Name of Proposal: Galleria Parkway Mixed Use Development

Review Type: Development of Regional Impact

Preliminary Report:	March 28, 2007	DEVELOPMENT OF REGIONAL IMPACT REVIEW REPORT	Project:	Galleria Parkway #1327
Final Report Due:	April 27, 2007		Comments Due By:	April 11, 2007

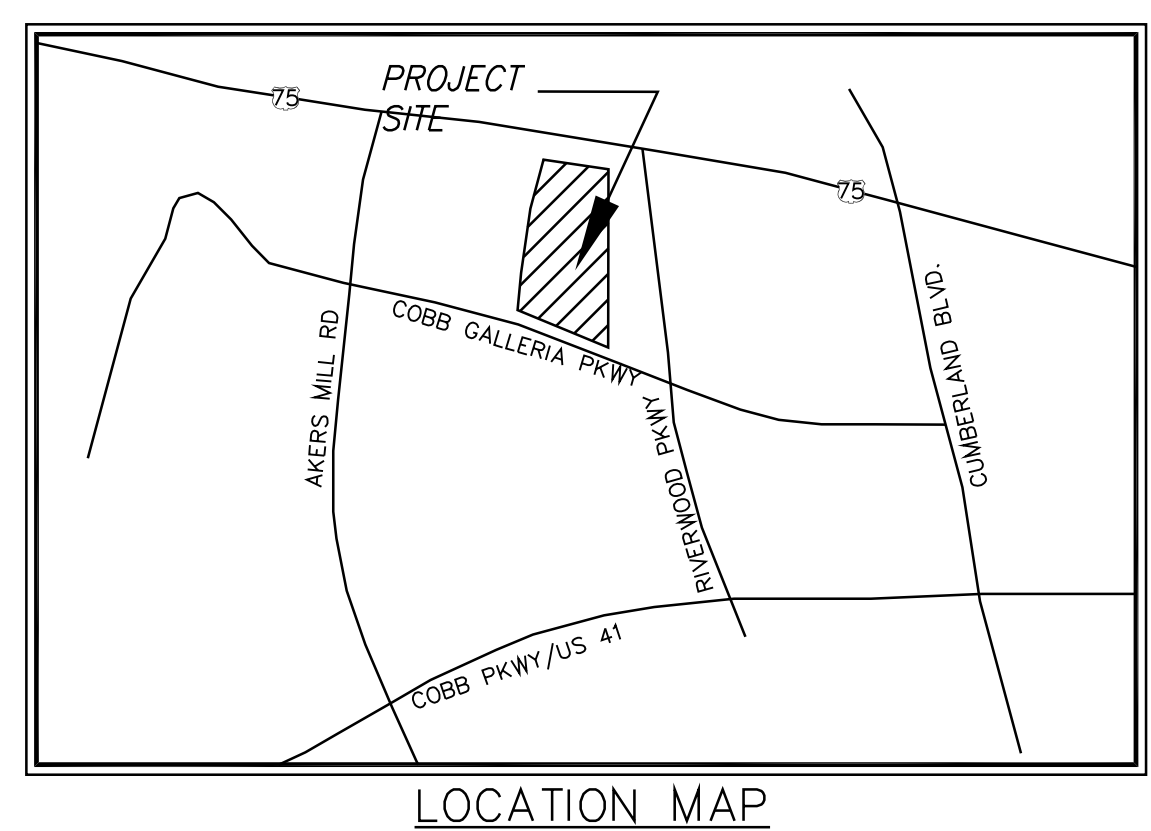
This proposed project includes two towers – a 16-level office tower and a 22-level hotel/condominium tower. The property drops sharply from the street level of Cobb-Galleria Parkway - from about 970 feet above mean sea level (MSL) to about 890 MSL at the back of the property along I-75. The preliminary plans show traffic access and building pads built out at approximately street level. This was the assumed base of the towers. ARC staff conducted an informal sightline study for the project, with profiles based on the 1:24,000 USGS quad sheet for the area (the Sandy Springs quad). Seven sightlines were drawn between the property and the river for the taller tower using the base elevation of 970 MSL and a tower height of about 250 feet above the base elevation. The lowest terrain between the site and the river was selected for the sightlines. Based on the sightlines selected, it appears that structures that are not higher than 1200 MSL (230 feet above the 970 MSL base elevation) will not be visible from the river until the I-75 bridge comes into view. However, we suggest that more detailed sightline studies be conducted to insure that the structures are not visible from the Palisades portion of the river.
